Redraw/modifications (c) Richard A. Cini	
Lomas Data Productcs	
Sheet: /	
File: s100_ColorMagic-1.1-004.kicad_sch	
Title: Lomas Color Magic Redux	
Size: USLetter	Date: 2024-08-16
KICad E.D.A. kicad (6.0.11-0)	Rev: 1.1-004
Id: 1/7

Title: Lomas Color Magic Redux

Rev: 1.1-004

File: s100\_ColorMagic-1.1-004.kicad\_sch

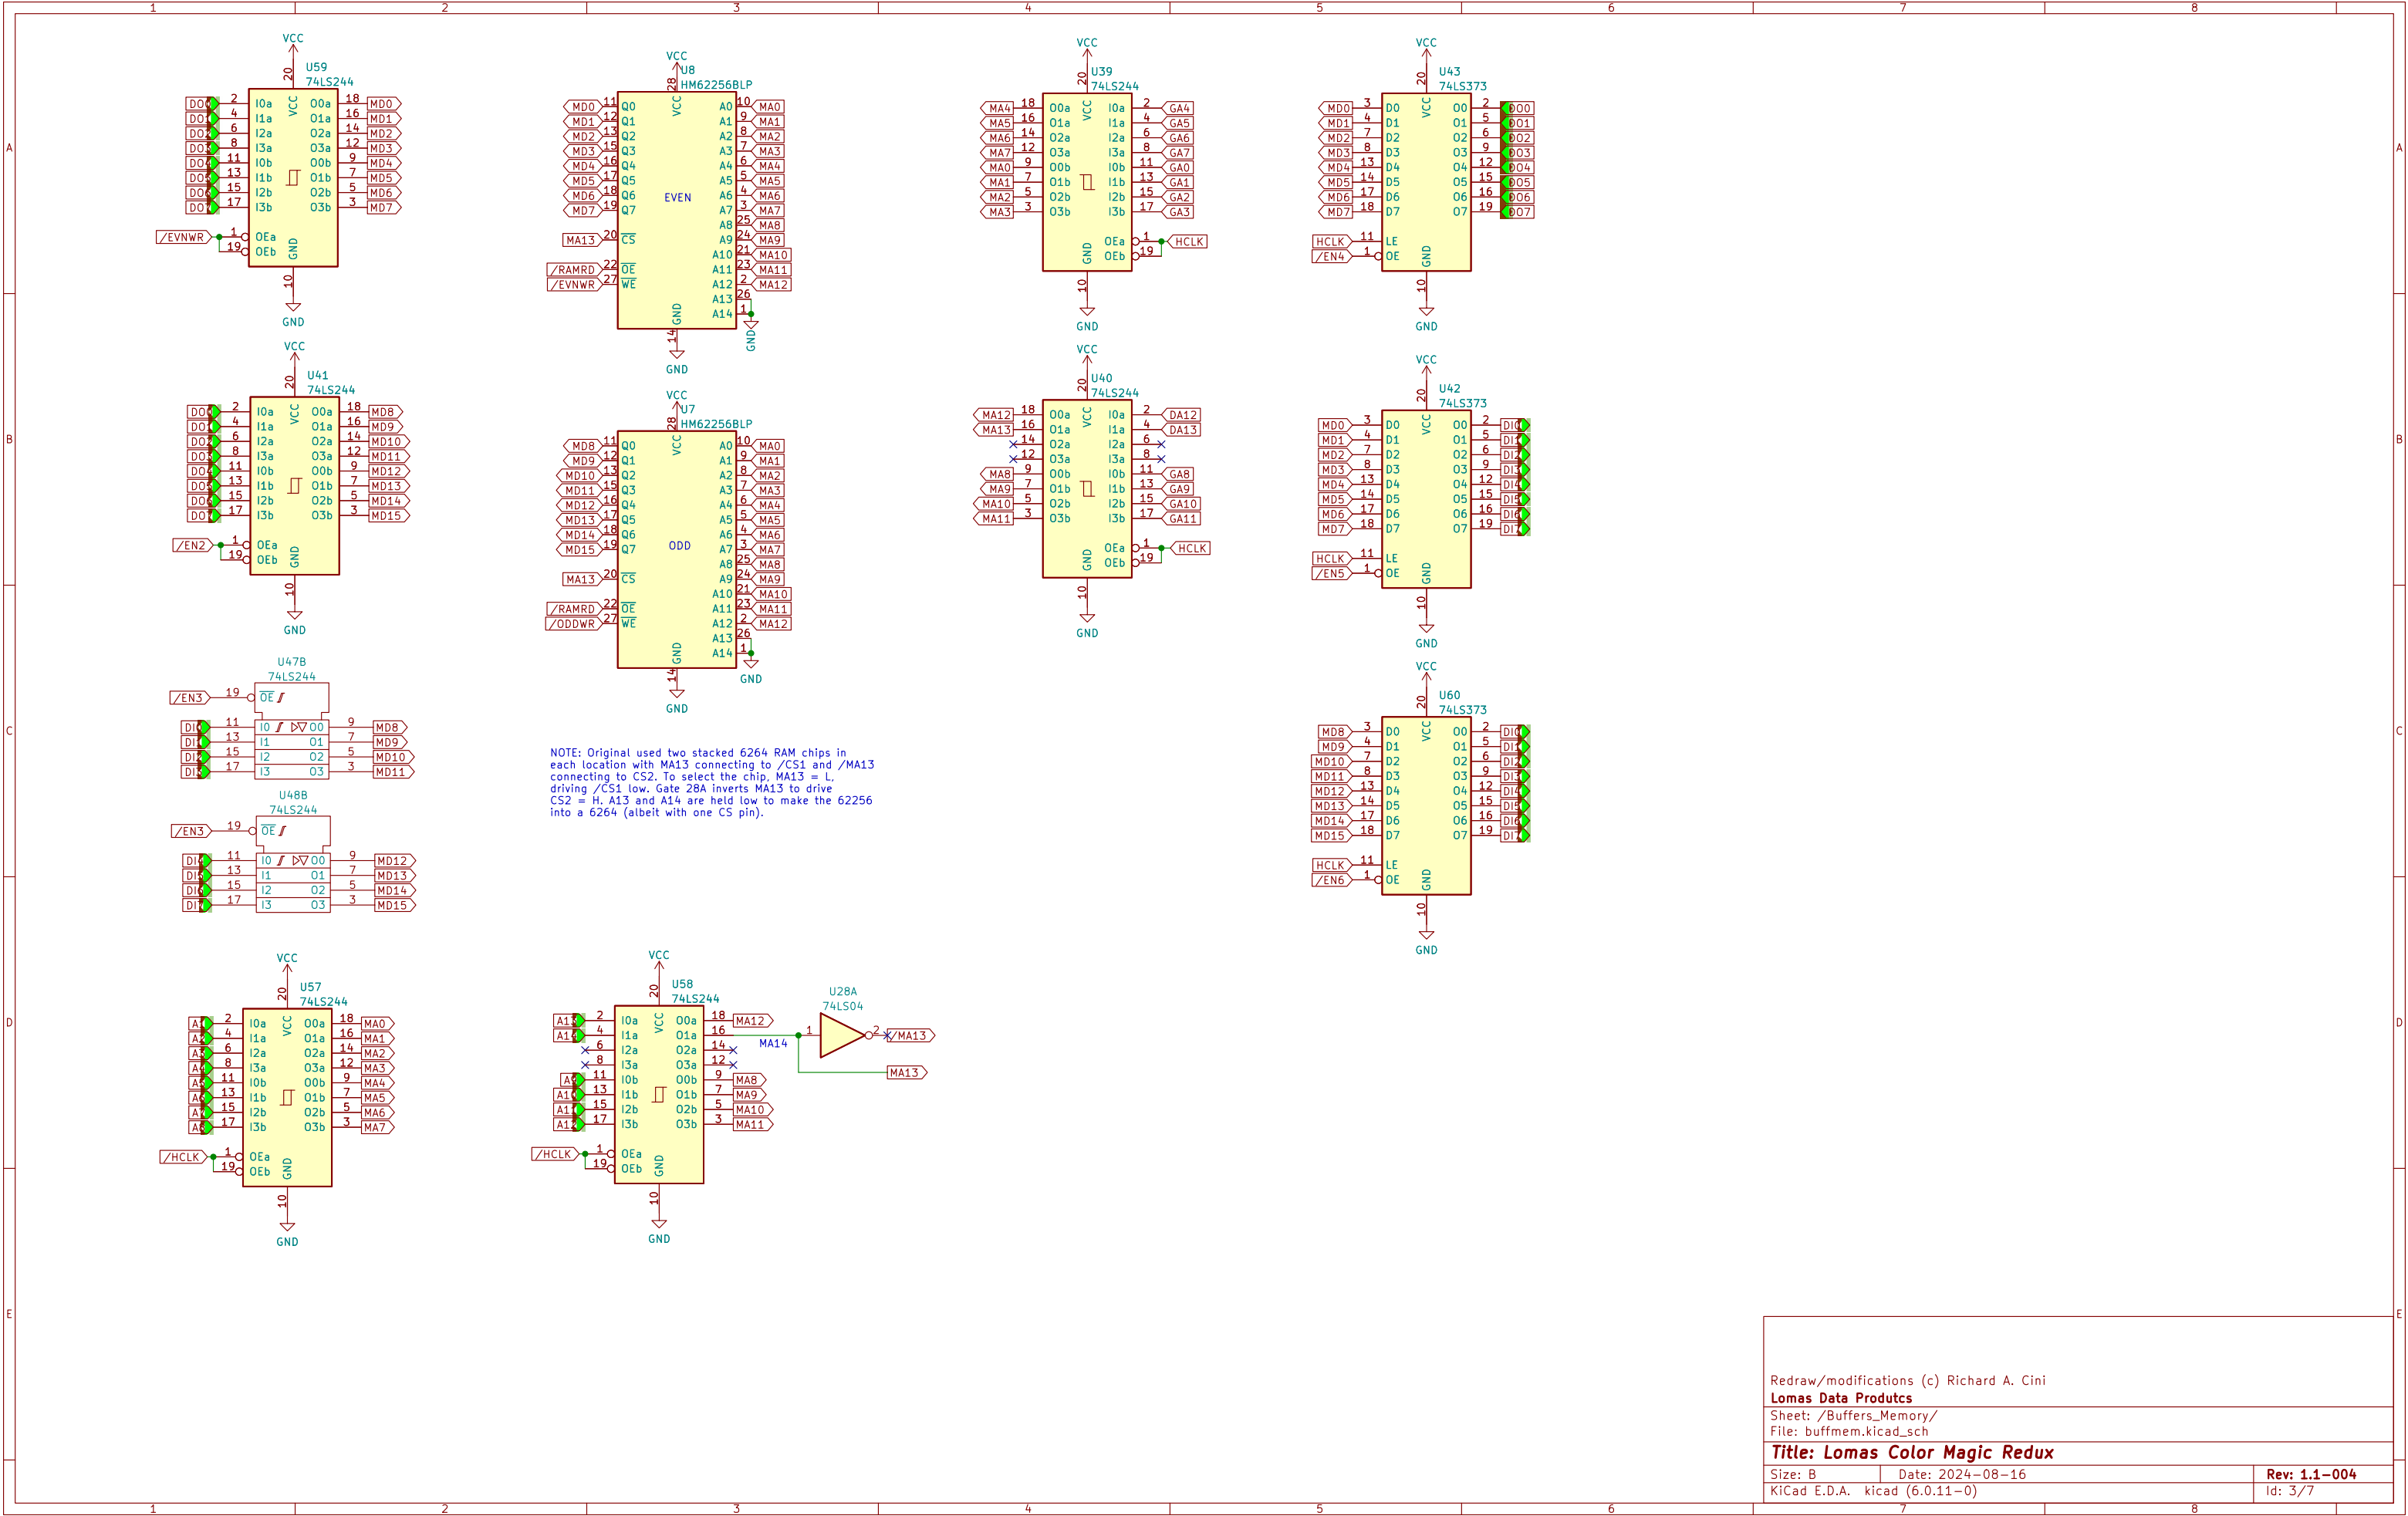
C	<div>ERRATA from 1.0 to 1.1-002:</div> <div>00. v1.0 of board was trashed.</div> <div>01. Resistor footprints are one size too small -- 1/4w uses 1/8w, etc. Due to space limitations, left at 1/8w.</div> <div>02. U49/78L12 silkscreen is backwards. Corrected.</div> <div>03. Several chips have unconnected VCC or GND leads that might be from the use of ONE and ZERO. Corrected.</div> <div>ERRATA from 1.1-002 to 1.1-003</div> <div>v.003 was never manufactured.</div> <div>ERRATA from 1.1-003 to 1.1-004</div> <div>01. J6 (address select) is flipped. Rotated 180.</div> <div>02. Design relies on SLAVE_CLR [54] for reset, but not all boards (like the SCP 200B) generate that signal. Reused spare gate of the LS125 and added a jumper and pull-up to generate that signal driven by POC [99].</div> <div>03. Changed memory chip wiring to be similar to the original, using MA13 as the CS* and grounding A13 and A14 of the 62256 (thus making it a 6264 albeit with only one chip select).</div> <div>04. Discovered that A6 is connected twice on U55. Changed second to A5.</div>					C
